## PLANNING REPORT

### PLANNING AND ZONING COMMISSION

SEPTEMBER 4, 2008

**1. Dublin Senior Living 08-080INF Summit View and Sawmill Roads Informal**

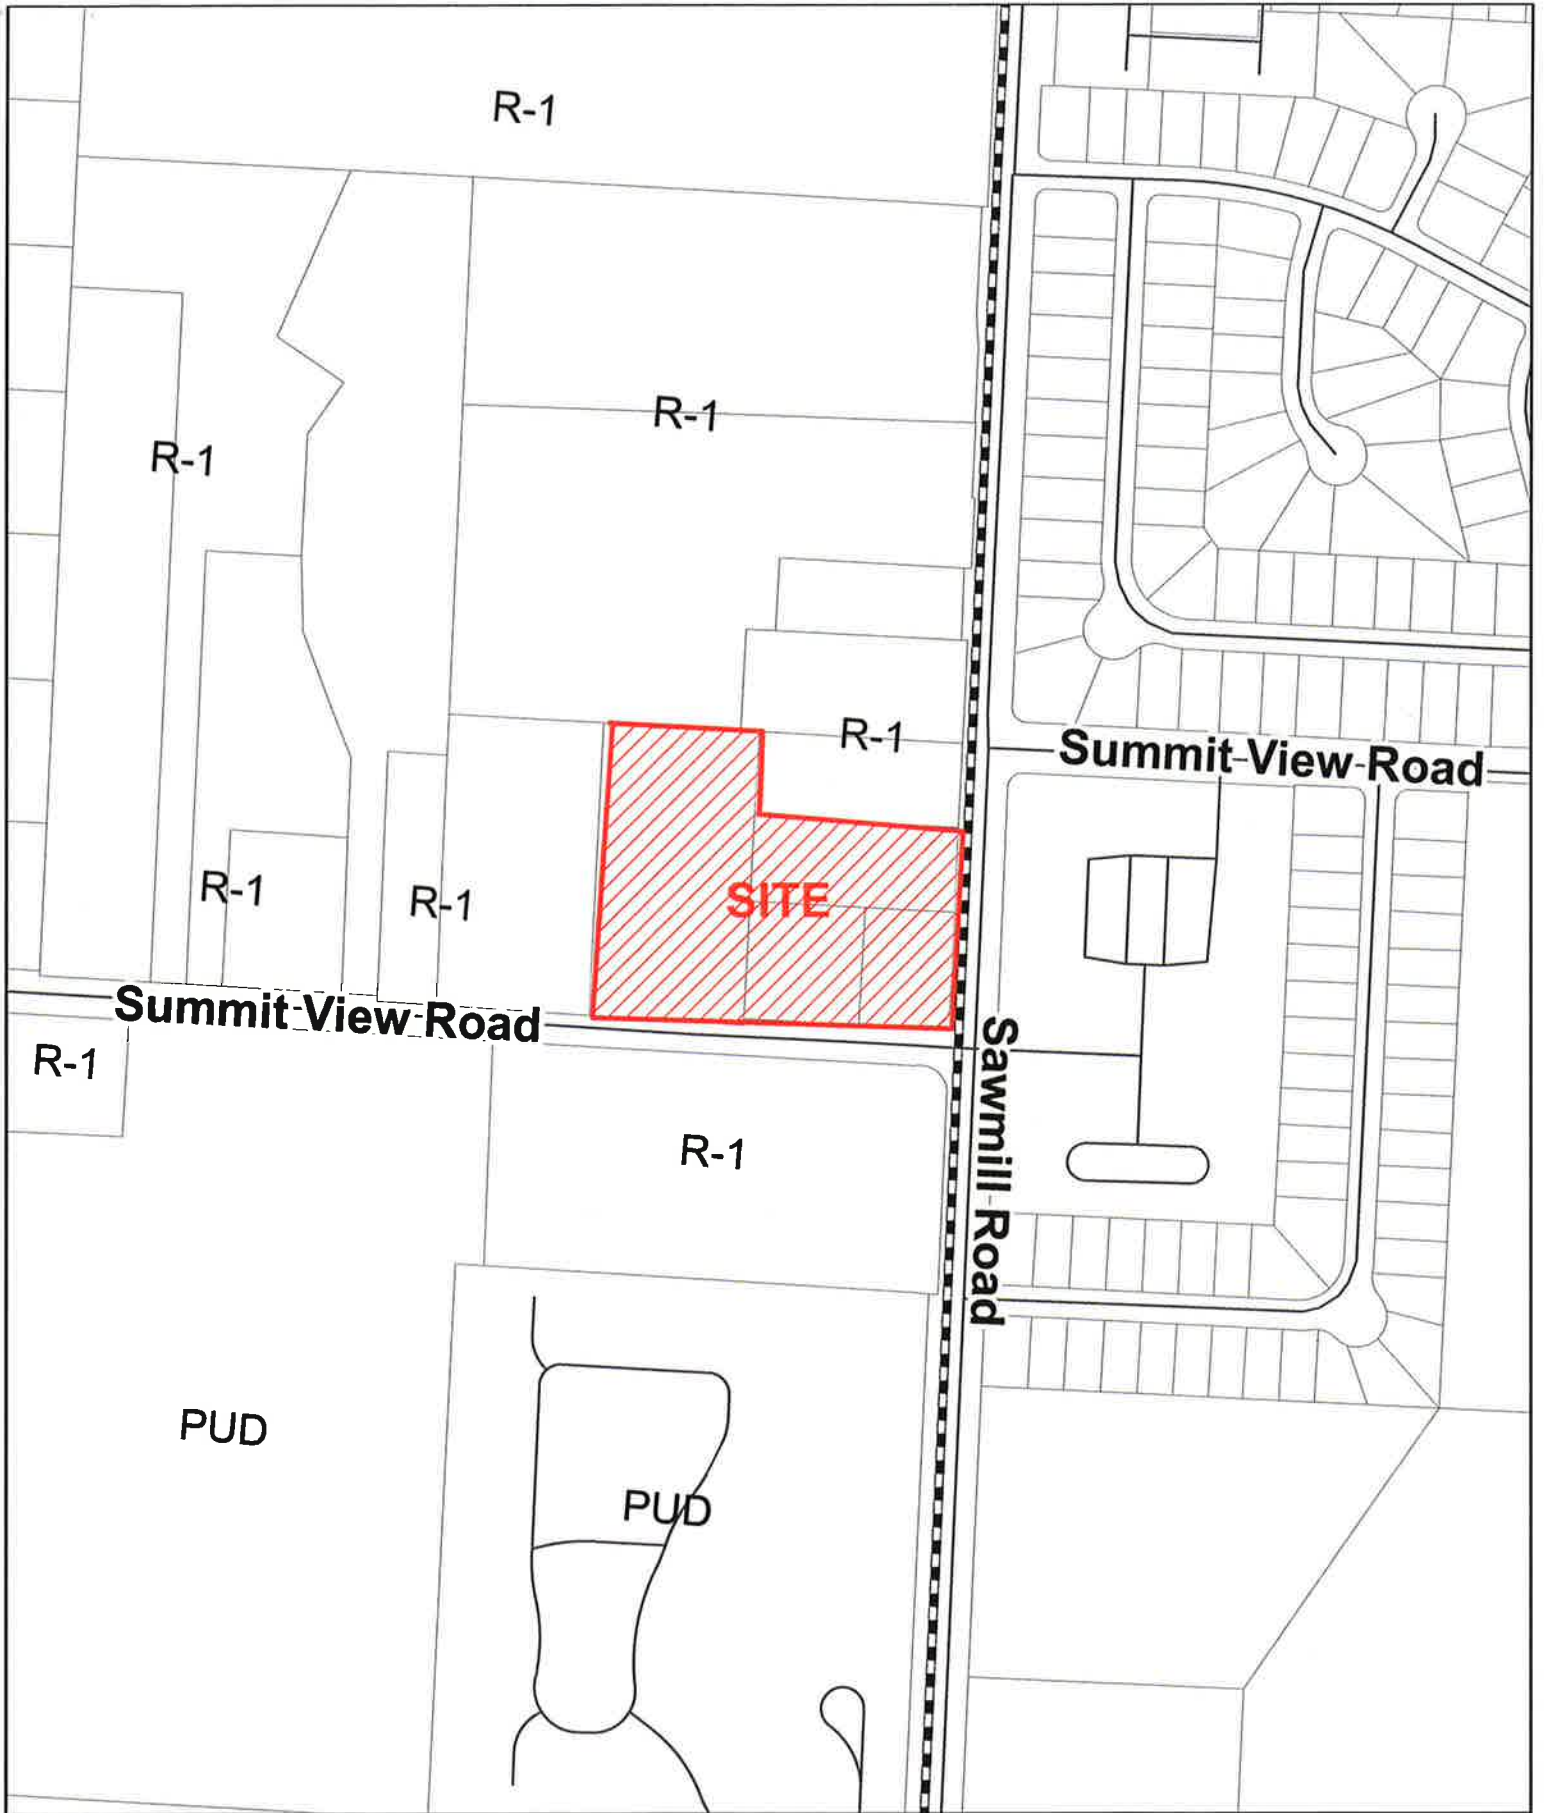
In Planning's preliminary opinion, the proposed use is consistent with the approved Area Plan which calls for lower intensity, non-retail uses; but the overall scale and density of the project need to be in keeping with the existing and desired future character of the area. The applicant would like feedback from the Commission prior to completing a concept plan and rezoning/preliminary development plan submission. Planning recommends that the Commission informally review the proposal and provide the applicant with feedback regarding any desired modifications to the layout or the architecture.

- The proposed use is appropriate and consistent with the Future Land Use map and the Summit View/Sawmill Road Area Plan.
- The overall scale and density of the proposed project make it difficult to achieve the objectives of the Area Plan with regard to streetscape character and pedestrian space along the public streets.
- The site layout needs to better integrate with potential adjacent development or for larger redevelopment of the Summit View/Sawmill area.
- The proposed architecture and building materials need additional refinement to create a more cohesive design.
- The extensive tree removal is dictated by the scale of the building.
- The preliminary plan will need to provide an effective and well-connected pedestrian circulation system.

- *Does the Commission view the proposed use as meeting the intent of the Summit View/Sawmill Area Plan to provide a transition away from the more intensive commercial and retail uses along Sawmill?*  
The goal of the Summit View/Sawmill Area Plan is to establish a quality neighborhood with a mix of residential and office uses that create a transition between the single-family neighborhoods and the Sawmill commercial corridor. While a residential development does not precisely meet the Future Land Use designation, it is consistent with the goal of the Area Plan to limit the further expansion of retail uses within this corridor.

- *Does the Commission think the height, scale and density of the project is appropriate and compatible with the character of the surrounding area?*  
The Area Plan also focuses on creating a streetscape and pedestrian space along the Summit View and Sawmill Road frontages that is of the appropriate mass and scale of the area and for development intensity with lower lot coverage.

- *Is the Commission concerned that the proposed architecture, while providing a variety of building materials and design elements lacks consistency?*  
The proposed architectural design utilizes a number of building materials, colors and design elements along each of the façades. There is no apparent pattern or consistency in the design of the building and the use of materials.
